Bulletin: SRA-V13-07
Date: December 4, 2013
Action Required? **YES**

Subject: Safety Recall, RVXX1307, L9 Seat Belt Buckles

SALTILLO MEXICO

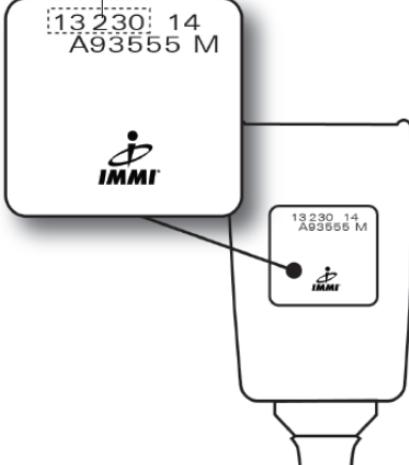
Suspect code range is
13220 through 13256

- 5) If your buckle code is within either of the ranges above, replace your buckle with the substitute buckle.
- 6) If your code does **NOT** fall within either range, you do **NOT** need to replace your buckle.

WESTFIELD, IN US

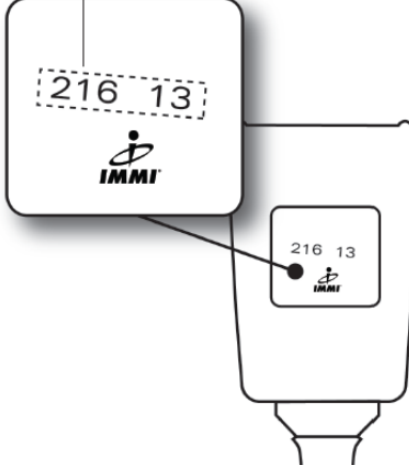
Suspect code range is
214 13 through 256 13
